**Re: Ardex Facility, SSD-25725029  
Response to Additional Request for Information  
Flooding and Flood Response**

SKETCH SHOWING ARDEX FACILITY AND  
APPROVED 1% AEP PRE-DEVELOPMENT  
FLOOD MODELLING  
Co13362.05-SKC01  
1 SEP. 2022

SKETCH SHOWING ARDEX FACILITY AND  
APPROVED PMF POST-DEVELOPMENT  
FLOOD MODELLING  
Co13362.05-SKC03  
1 SEP. 2022

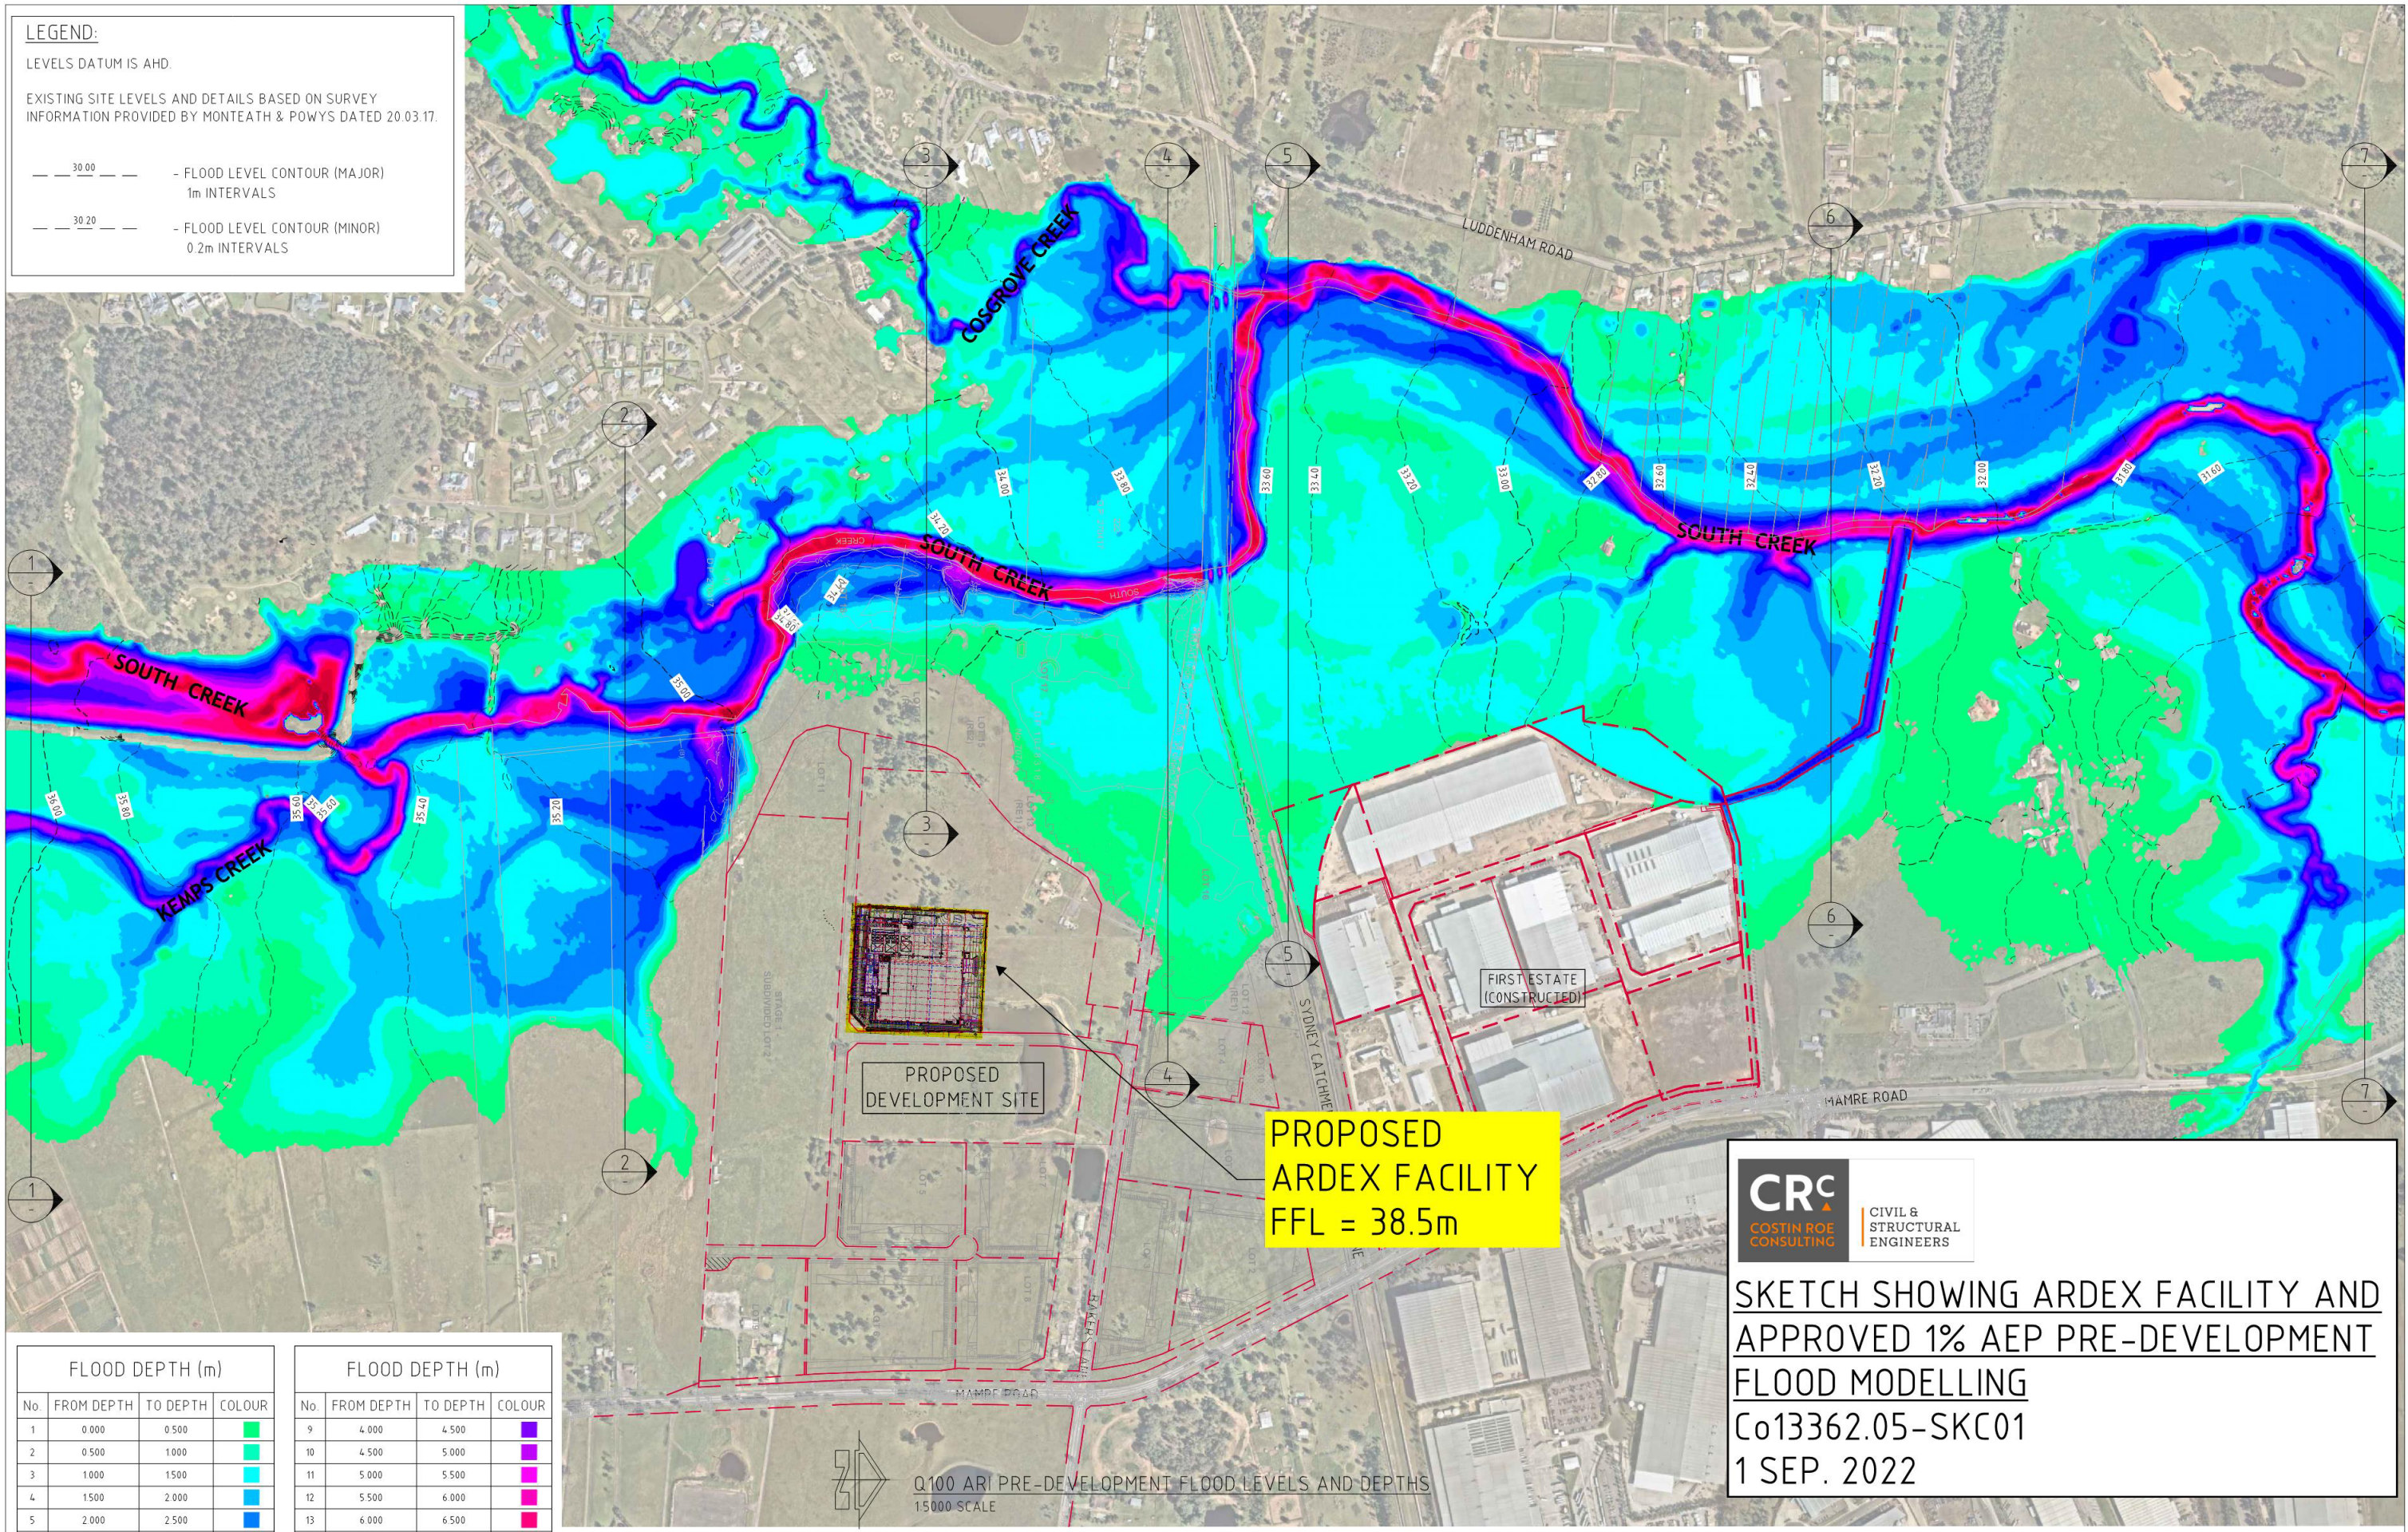
*5. The Civil Engineering Report (Appendix C3 of the RtS) states that potential flooding impacts as a result of post-development flows were assessed under SSD-9522. The Department notes that the details of the proposed cut, fill and construction works did not form a part of the flood assessment completed under SSD-9522. Please explain how flooding impacts of the proposed development were adequately addressed under SSD-9522 or provide an addendum to the Civil Engineering Report to address this issue.*

Sketches **Co13362.05-SK01** to **SK03** are included in **Enclosure 2**. These sketches show the Ardex Facility overlain over the approved 1% AEP pre and post development flood extent drawings, and the PMF post development flood extent drawings respectively. The pre and post development 1% AEP flood level is RL 34.4m AHD and the PMF is RL 36.4m.

Noting the proposed floor level of the building is RL 38.5m AHD, and the approved SSD-9522 filling level varied between RL 37.2m and RL 38.4m AHD, both the approved SSD-9522 filling levels and proposed SSD-

25725029 building are clear of both the 1% AEP and PMF levels. The construction of the proposed Ardex Facility as such will not change any outcomes achieved in the approved SSD-9522 flood impact assessment.
